## SUPPLEMENTAL REMEDIAL INVESTIGATION WORKPLAN (REV. 1)

RIVER PLAZA SHOPPING CENTER
130 WILDEY STREET
SECTION 01, TAX SHEET 2, LOTS P-25 AND P-25B
TARRYTOWN, WESTCHESTER COUNTY, NEW YORK
NYSDEC SITE ID NO.: 360084

SUPPLEMENTAL REMEDIAL INVESTIGATION WORKPLAN (REV. 1)

# FIGURE 2 Site and Sample Location Plan

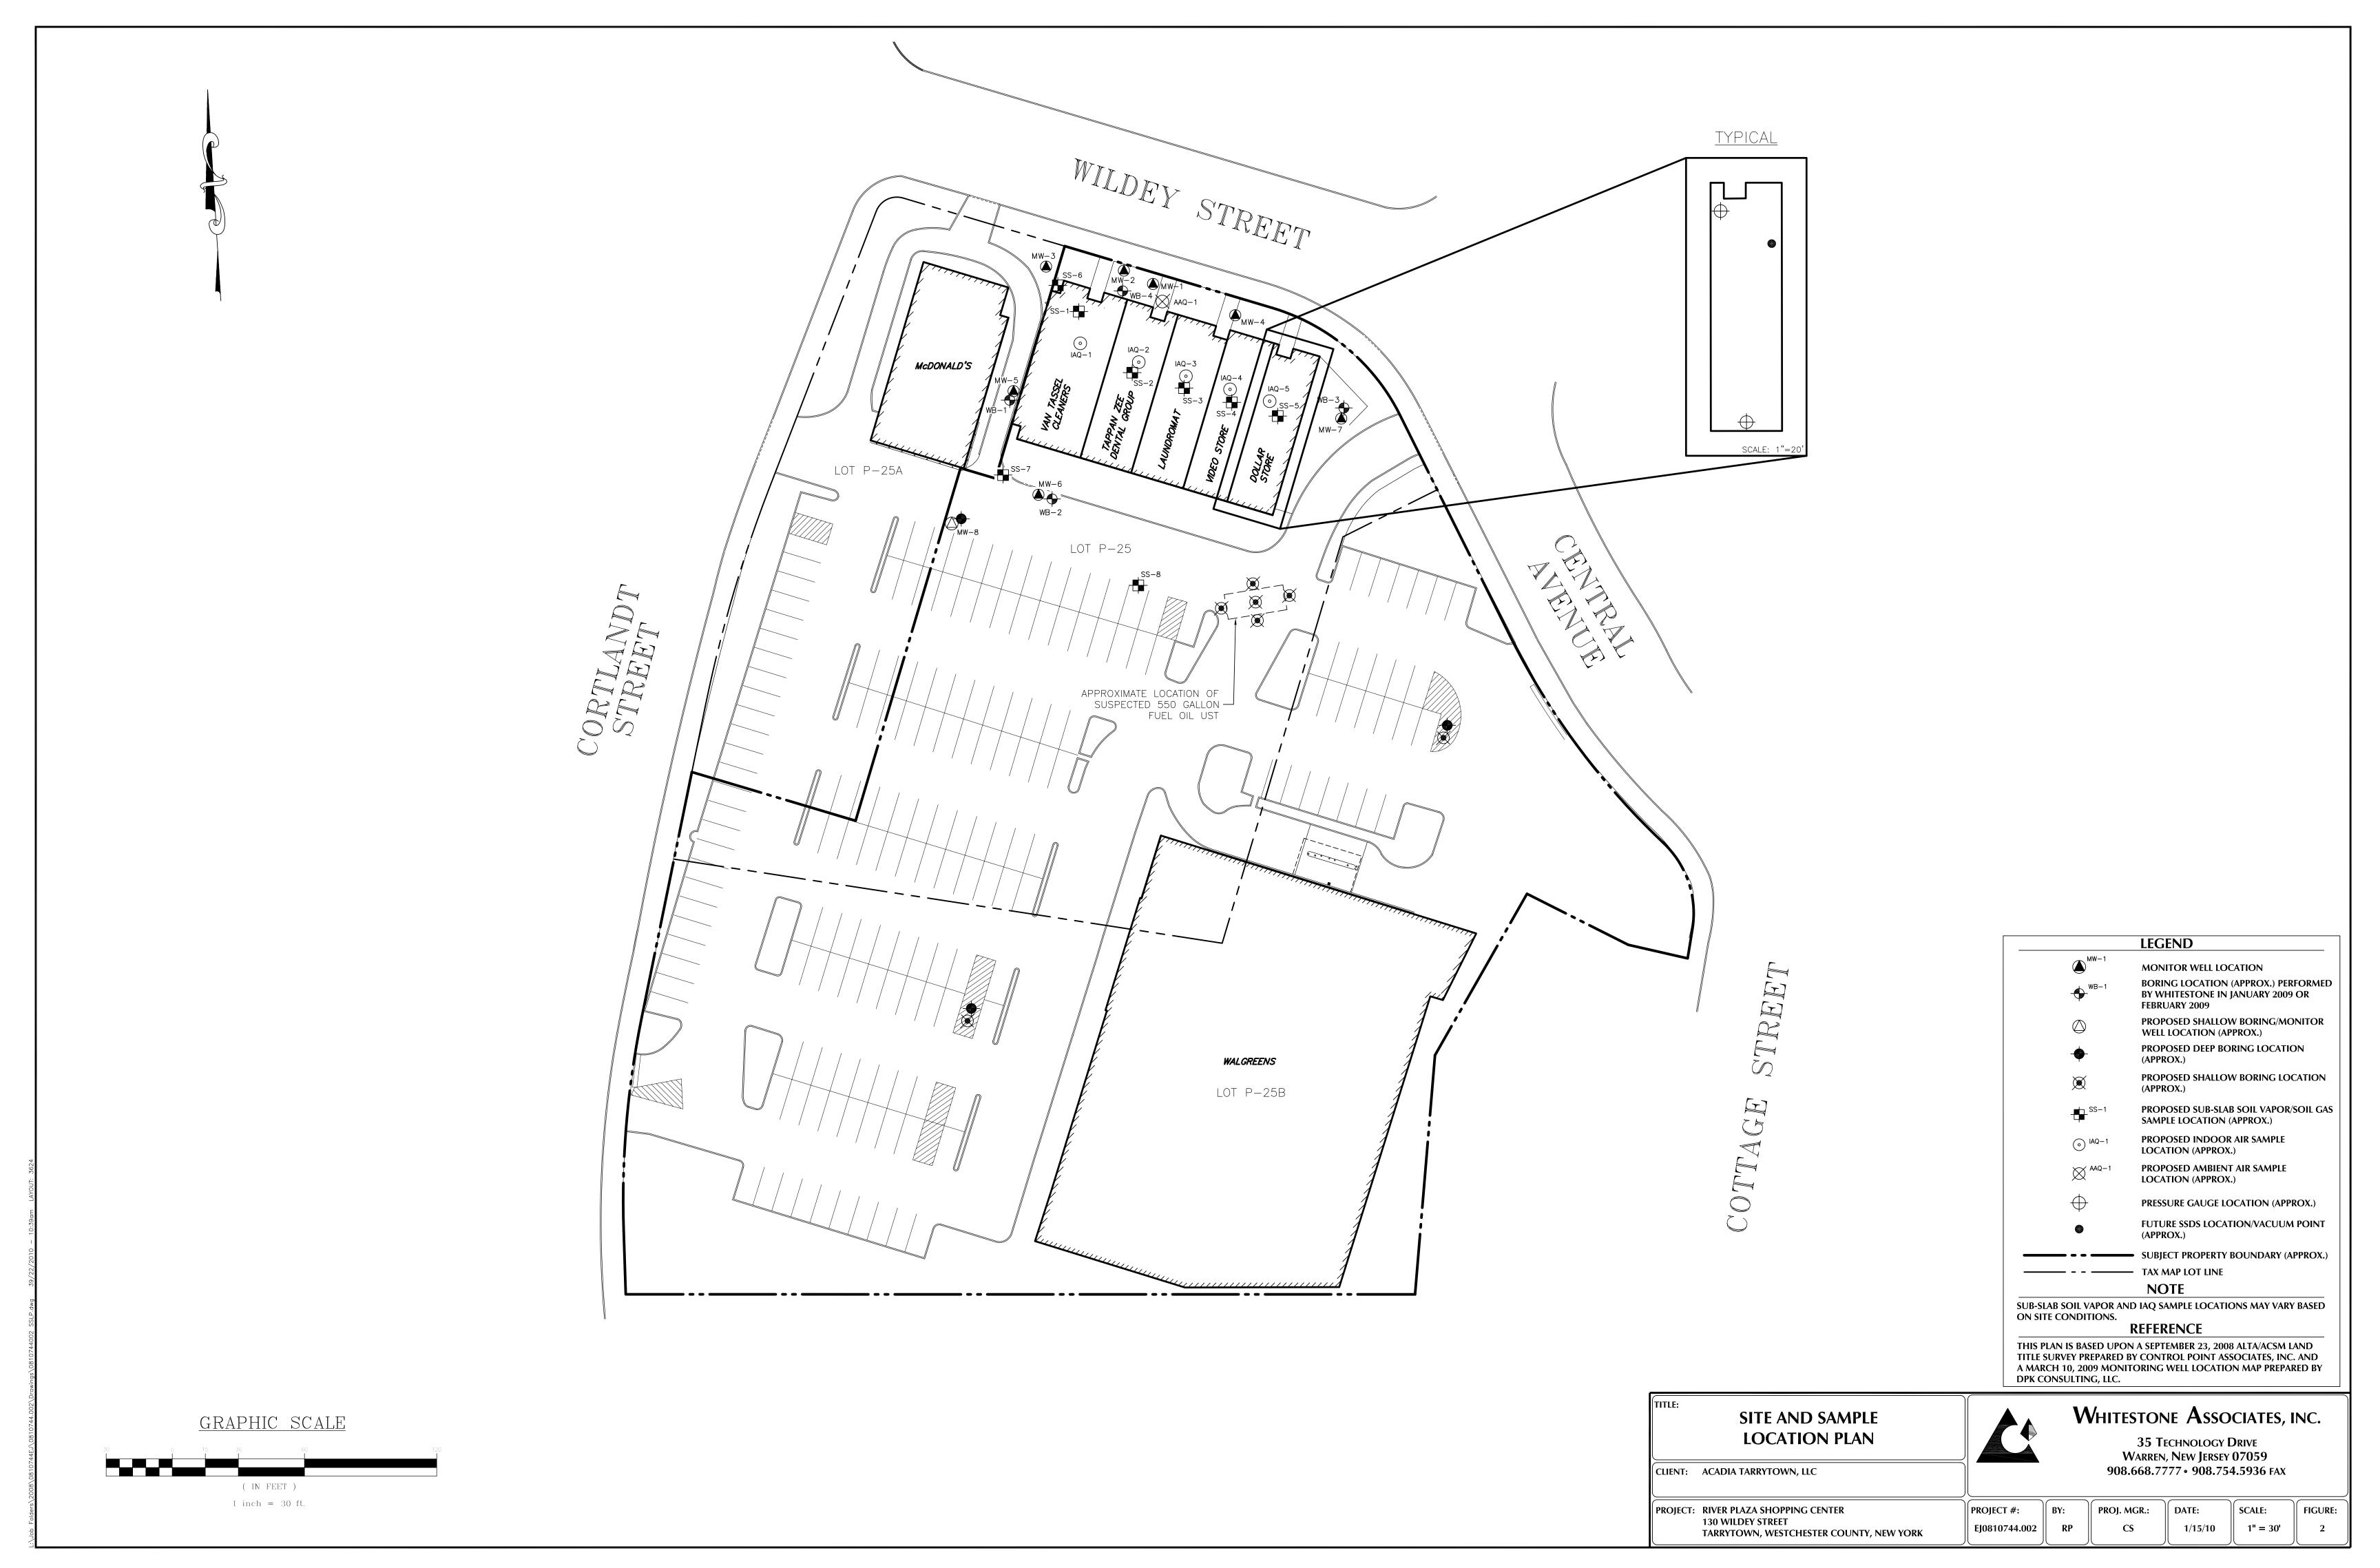
- 20. Section 2.1.1: Please include a site plan that shows the entire site, including the tax parcels. This section states that Figure 2 shows the entire site, but it is not reflective of the entire 3.3-acre parcel.

- **Comment 19:** An updated Project Schedule is included in Section 4.0 of this report.
- Comment 20: Figure 2 of this SRIW includes the entire site as defined in the December 18, 2008 *Modification to Order on Consent.* This figure will also be included in the comprehensive RIR.
